2000-1 Addison Circle

Roundabout Design & Operational Review (Lee  
Engineering) - 2005

**ADDISON CIRCLE  
DESIGN, OPERATIONS, AND SAFETY REVIEW**

July 2003

**FIGURE 18:  
POSSIBLE LANE MARKINGS TO REDUCE  
CONFLICTS AT NB QUORUM EXIT  
5-15-5 LANE LINE**

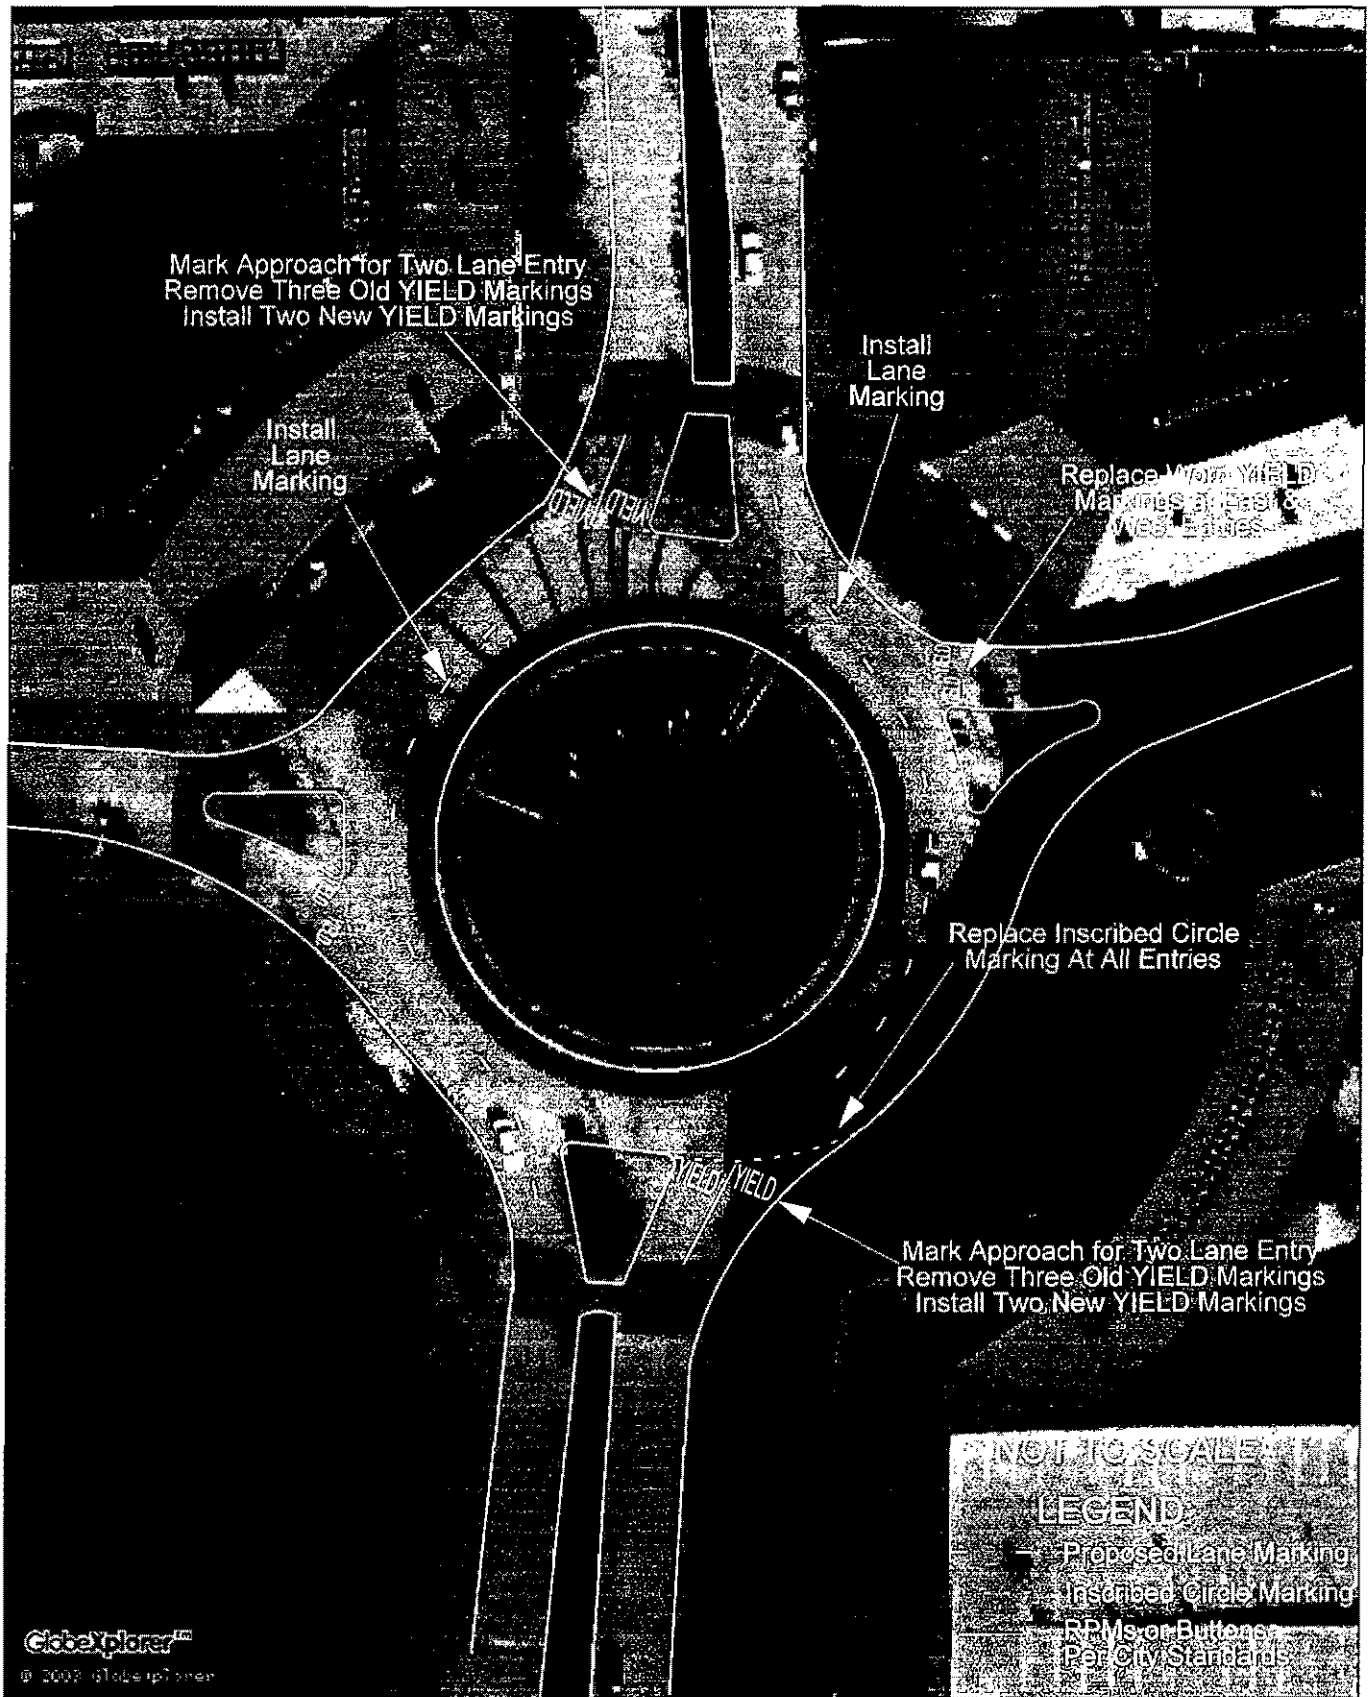
- The following improvements are all referenced in *Figure 18*.
- Remove pavement markings on northbound and southbound entries that indicate a three-lane approach. Reinstall new markings for a two-lane entry to the roundabout. Ensure that markings align with desired position within the roundabout.

- Replace worn “YIELD” markings on the eastbound and westbound entries.
- Broken white line inscribed circle markings should be reinstalled as shown in *Figure 18* as they provide a visual cue as to the edge of the circulatory roadway.

- Install white lane markings along center of circulatory roadway to guide traffic entering the roundabout from the south into the proper position for the northbound exit. White lane markings should be of a 5'-15'-5' spacing pattern as shown in *Figure 18*. Install similar lane markings for southbound through movement.

FIGURE 19:  
SAMPLE GUIDE SIGN  
WITH LANE USE

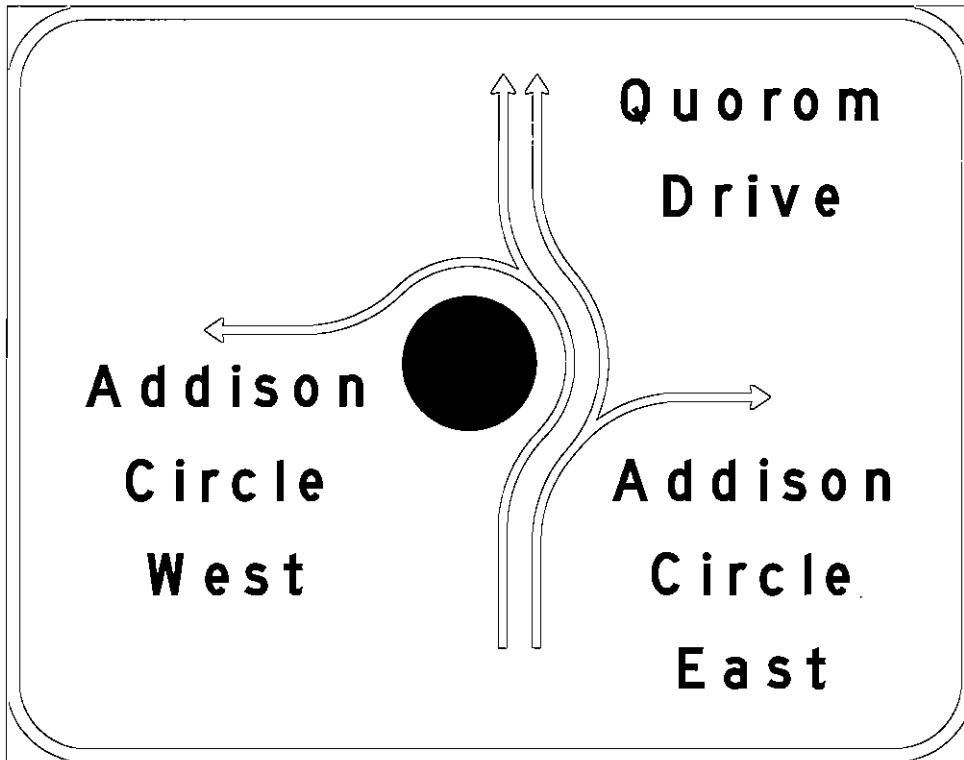
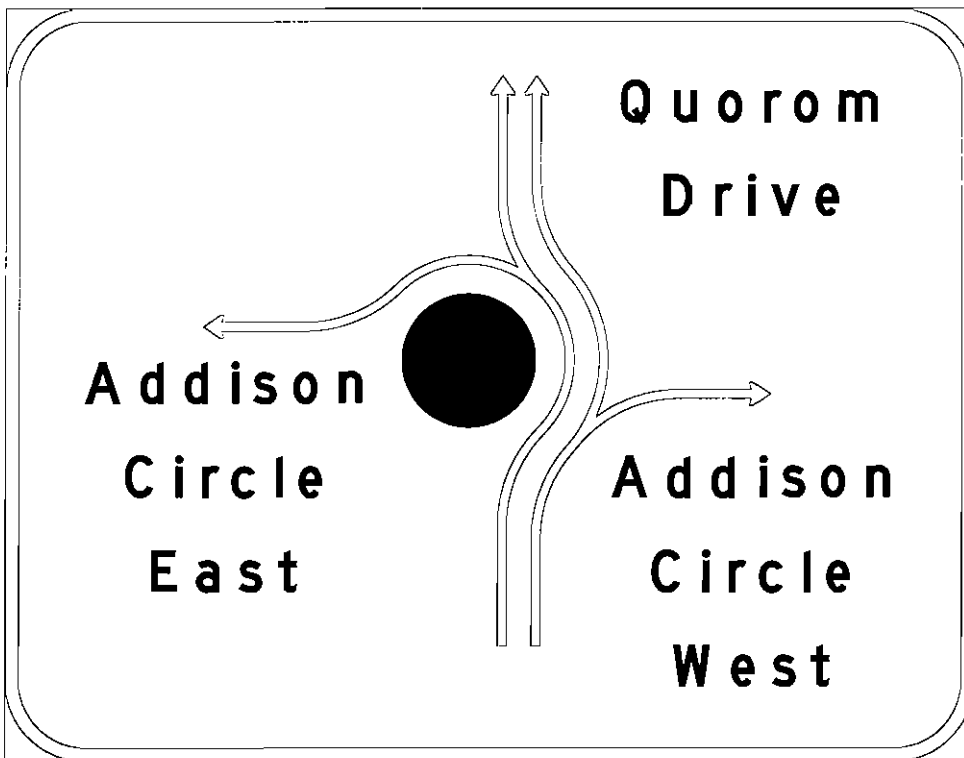
- Consider replacing the existing green roundabout guide signs with one that indicates lane use, such as those shown in *Figure 19*. While the large guide sign may still be aesthetically unpleasing, adding suggested lane use indications will alleviate some concerns that existing signage does not tell the motorist enough about how to drive the roundabout.

**FIGURE 20:  
ENCOURAGE CROSSWALK USE THROUGH  
PEDESTRIAN ACCESS RESTRICTIONS**

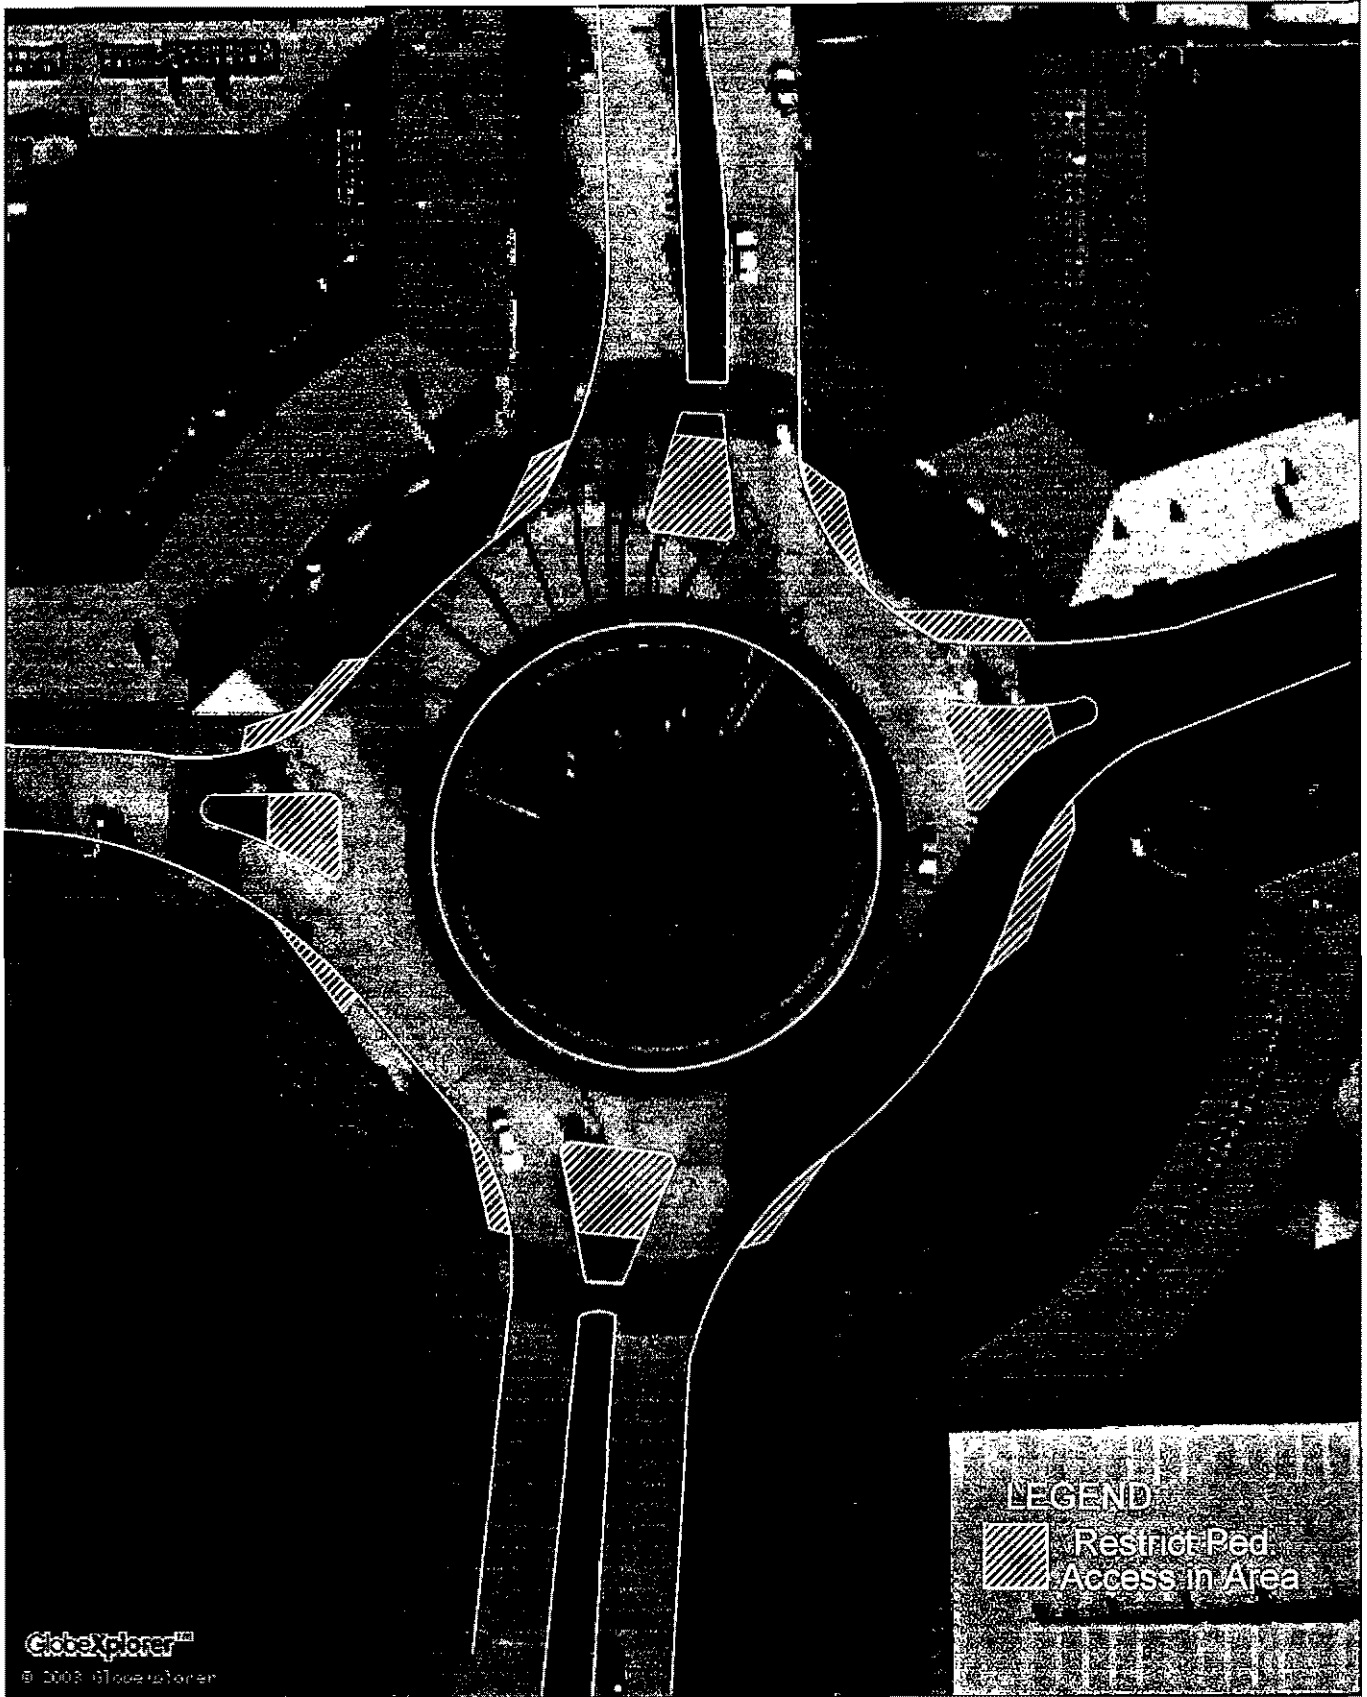
- On curb radii and splitter islands between the crosswalk and circulating roadway, planter boxes or other landscaping treatments should be installed to better direct pedestrians to the existing crosswalk facilities. These areas are represented by hatching in *Figure 20*.
